ADDENDUM No. 6 – February 11, 2019

S E-ADDENDUM No. 1 – May 1, 2018

PROJECT TITLE:
EARLY SITE BID PACKAGE #2
South High Community School
170 Apricot Street, Worcester, MA 01603

DRAWING NUMBER: ADD-3 C-028	SHEET REF. NO. C3.3
	DRAWING NAME: Site Demolition Plan Sketch
DATE: 09/17/18	SCALE: AS NOTED

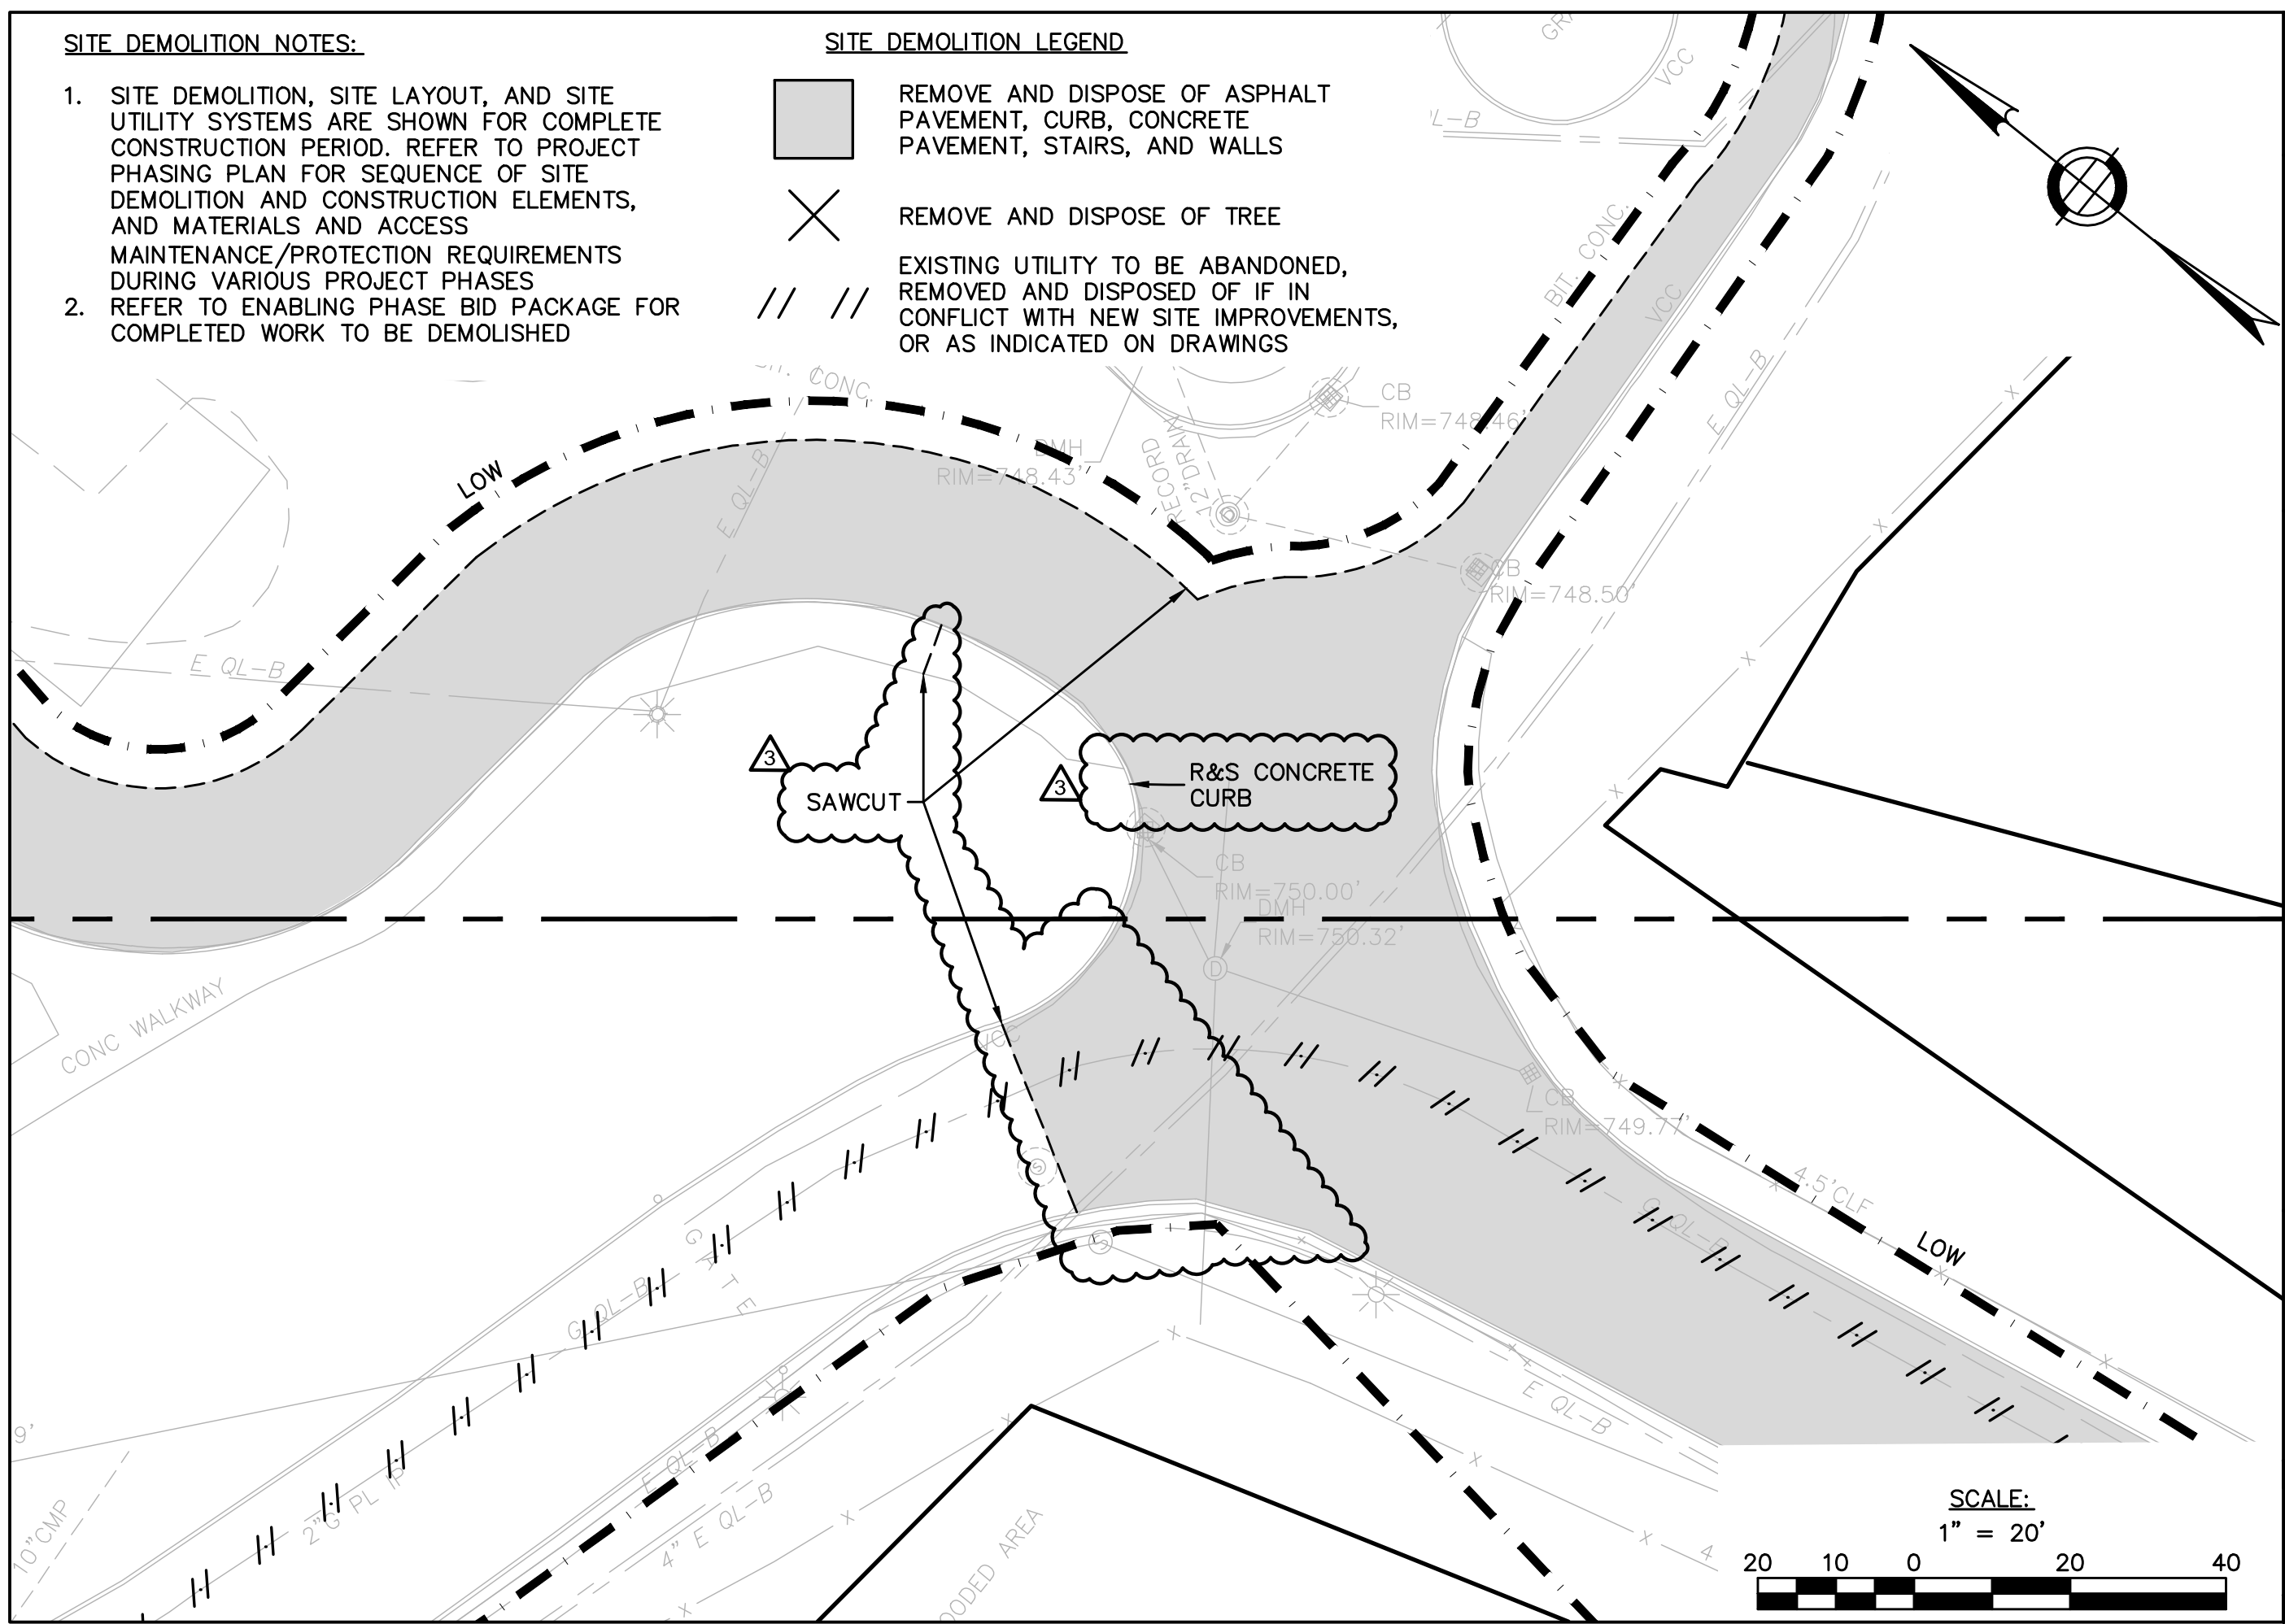
2. DRAWING C3.3 – Site Demolition Plan

- A. Refer to sketch ADD-3/C-028

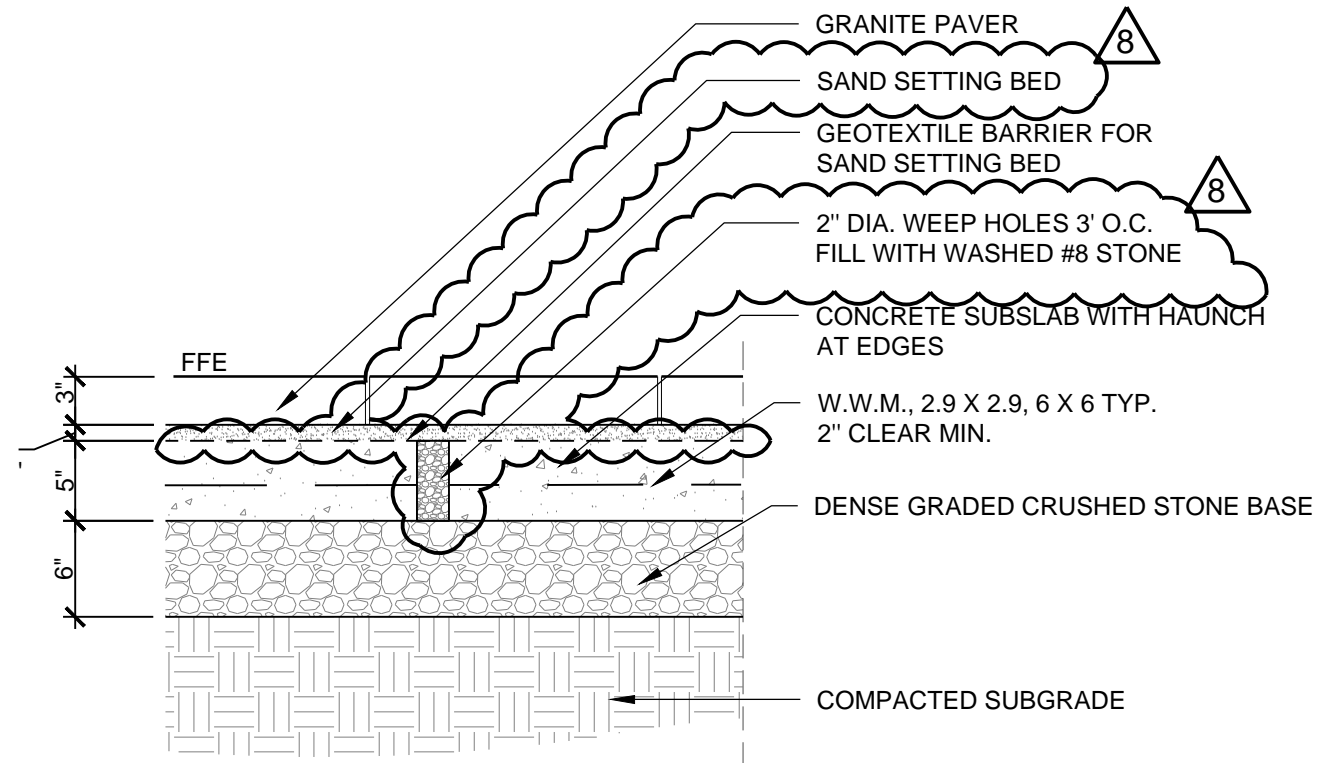
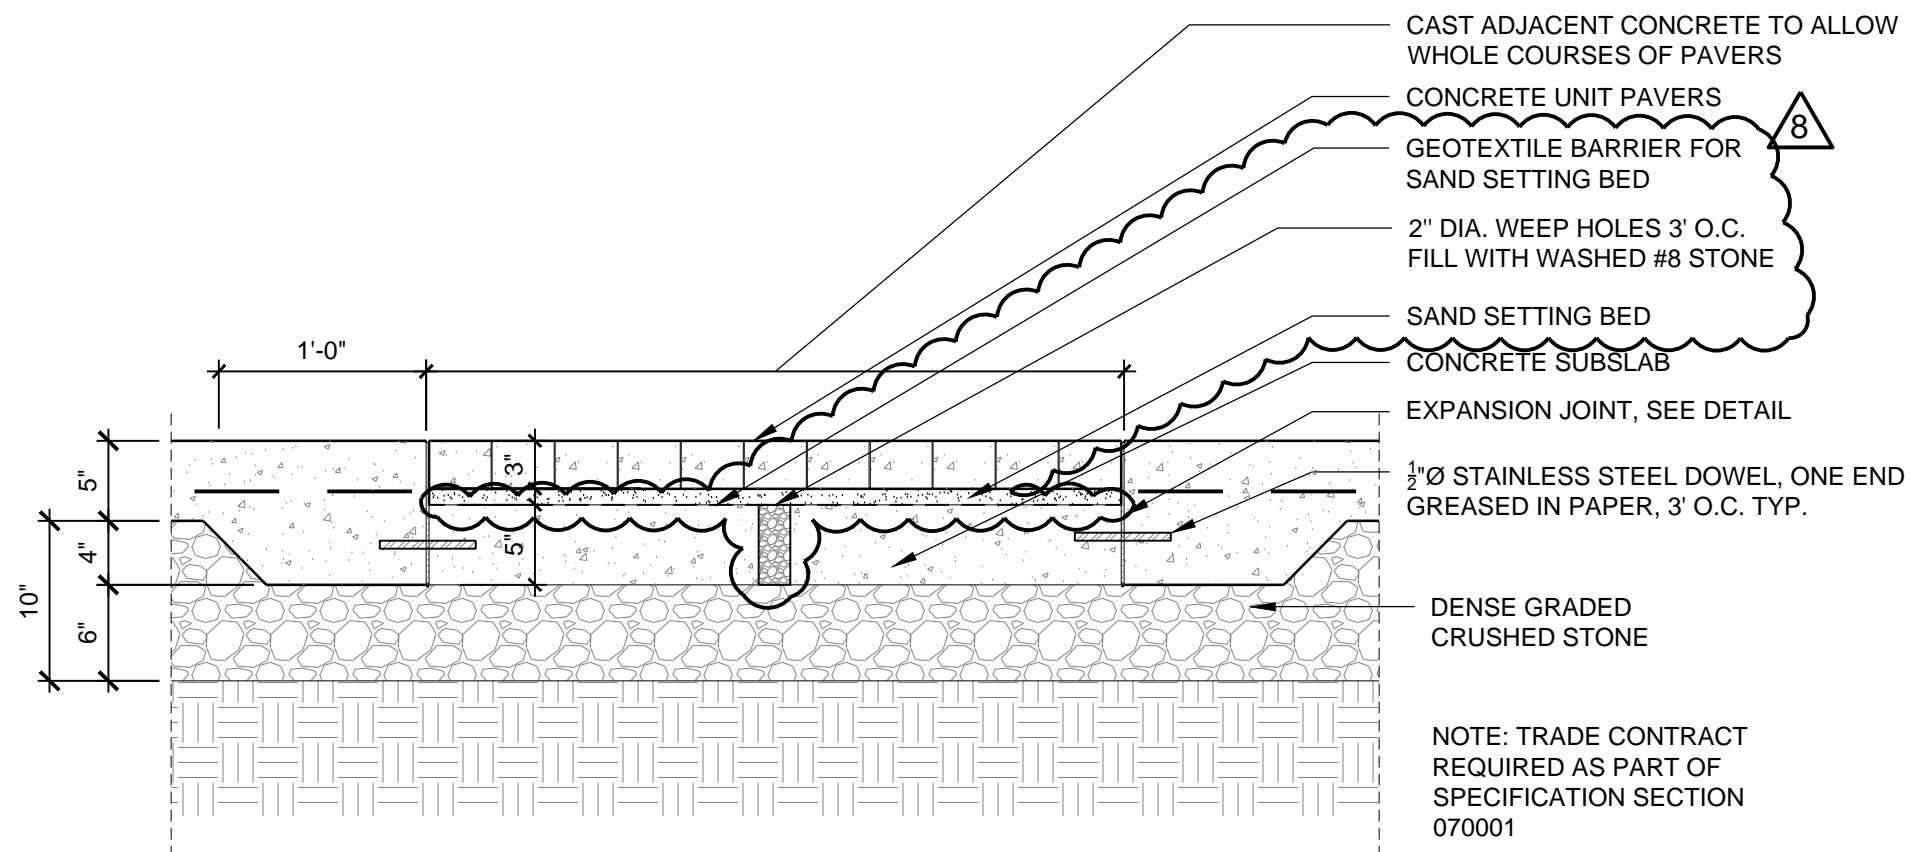
8 Changed setting bed to sand for all concrete and granite pavers. Drainage holes are to be drilled 3' o.c. in the concrete sub slab and filled with #8 stone. Filter fabric should be laid between the concrete sub slab and the sand setting bed.

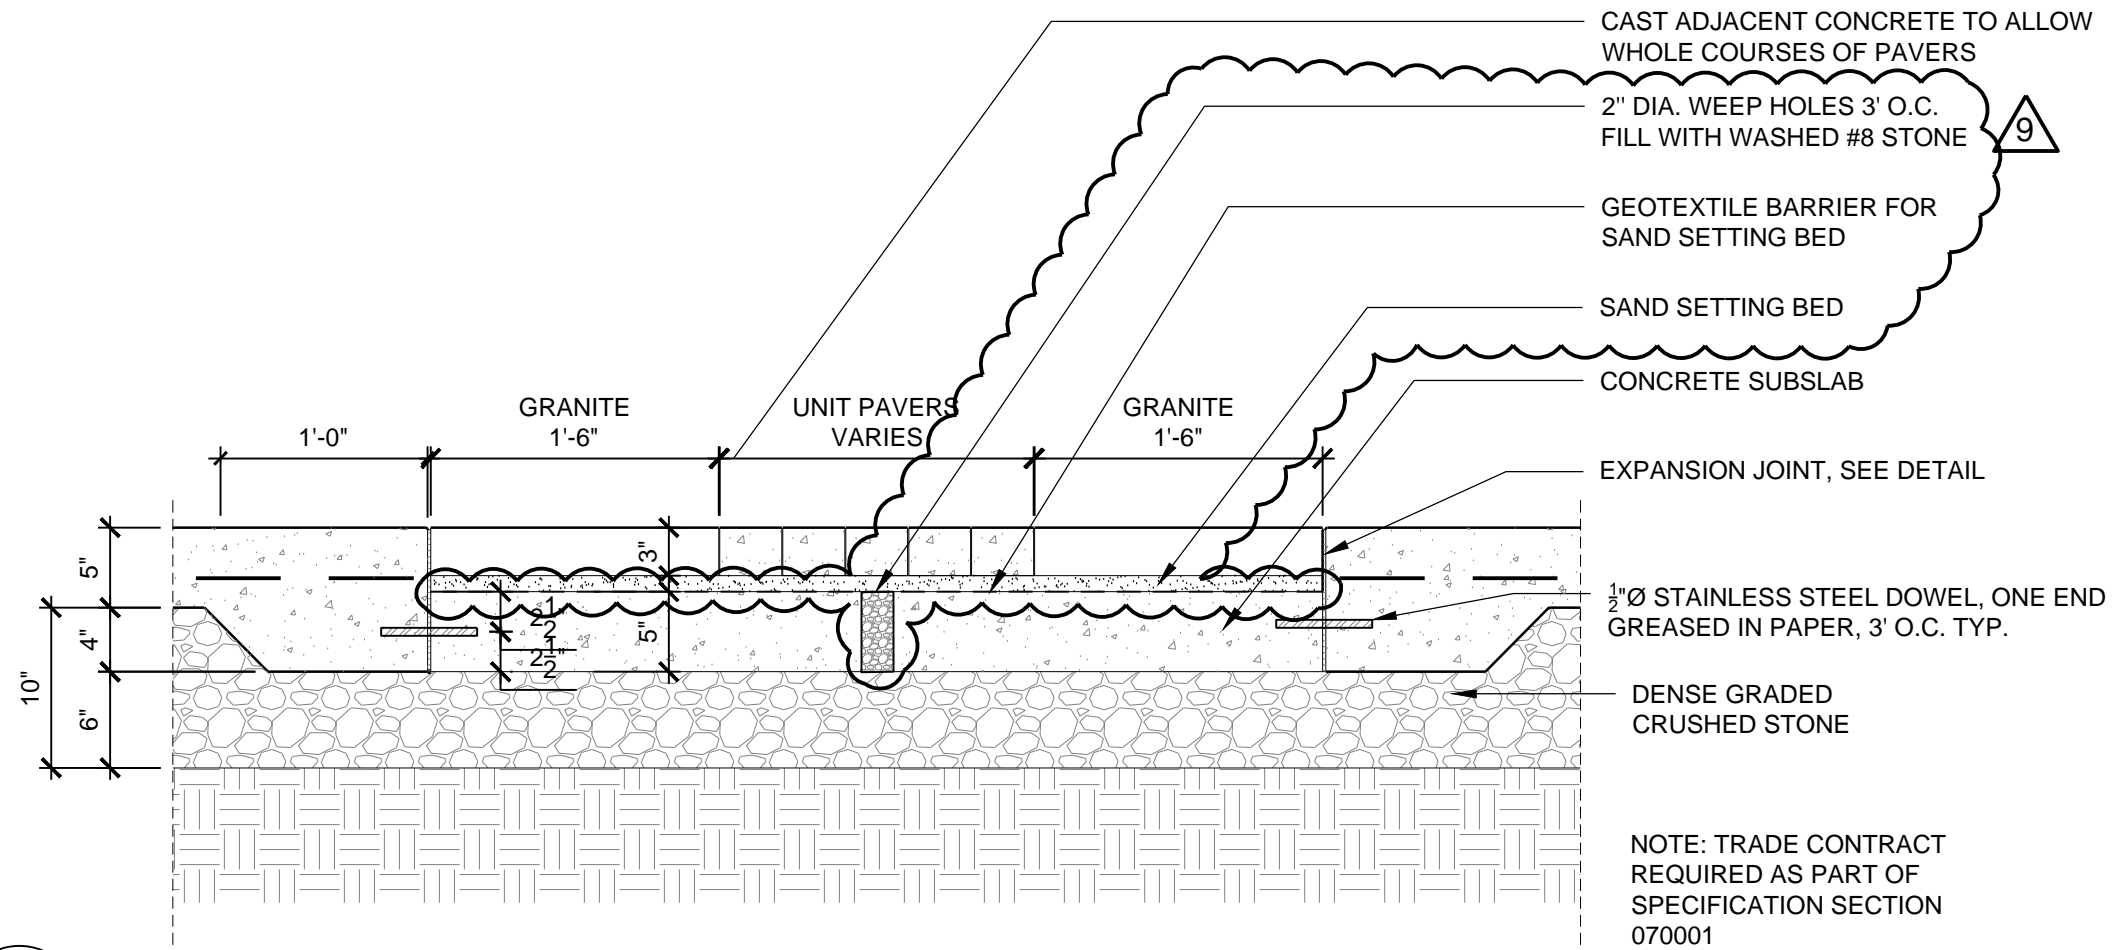
9 Changed setting bed to sand for all concrete and granite pavers. Drainage holes are to be drilled 3' o.c. in the concrete sub slab and filled with #8 stone. Filter fabric should be laid between the concrete sub slab and the sand setting bed.

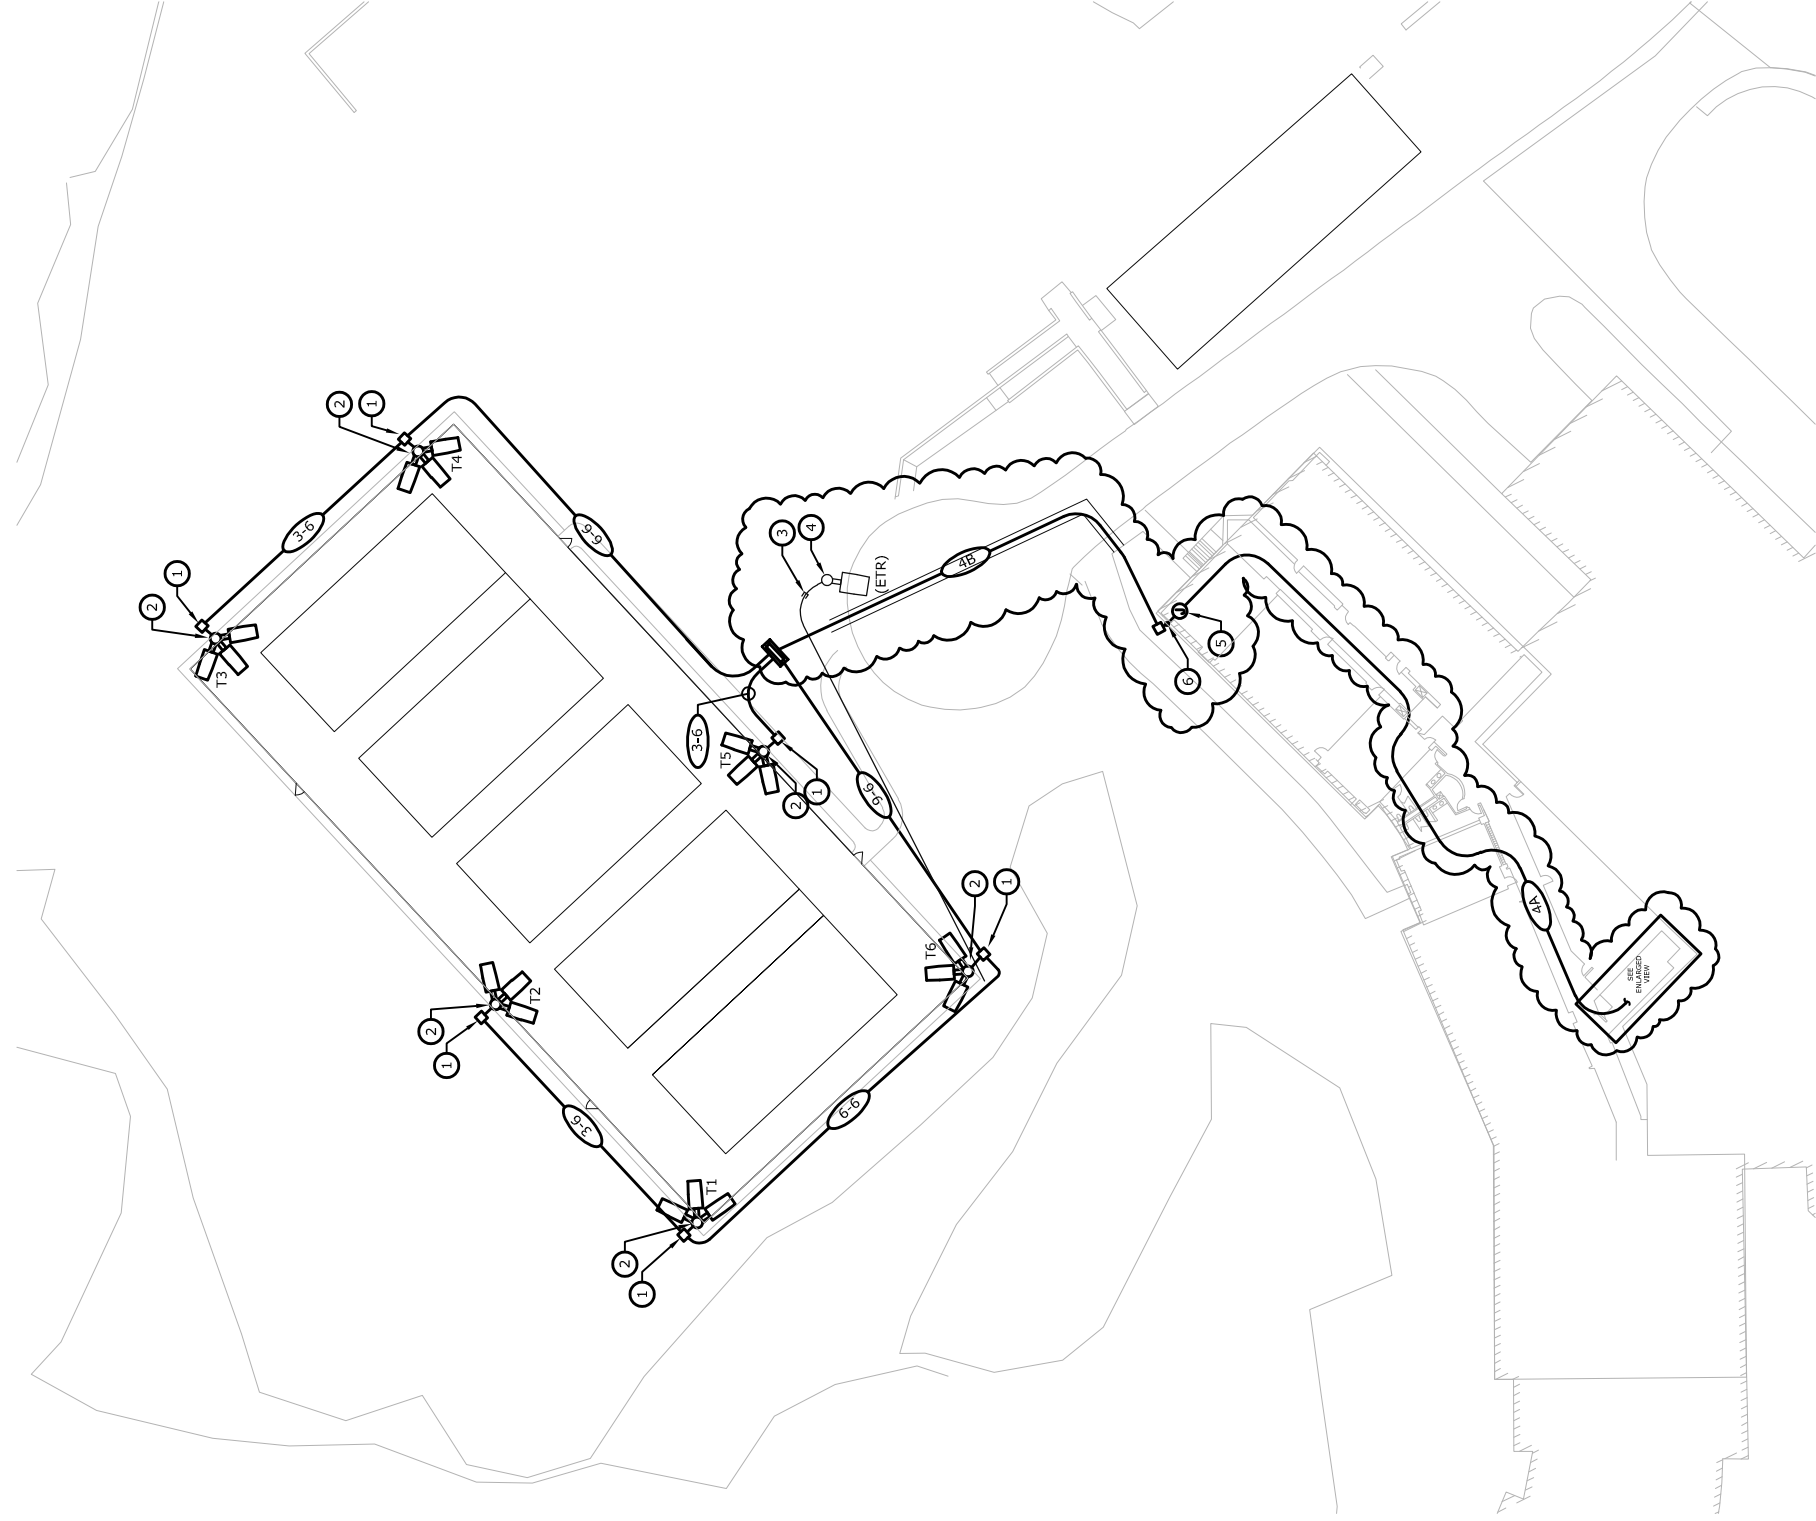
ADDENDUM NOTES:

1. RUN CONDUIT THROUGH SULLIVAN MIDDLE SCHOOL TO AVOID WETLANDS
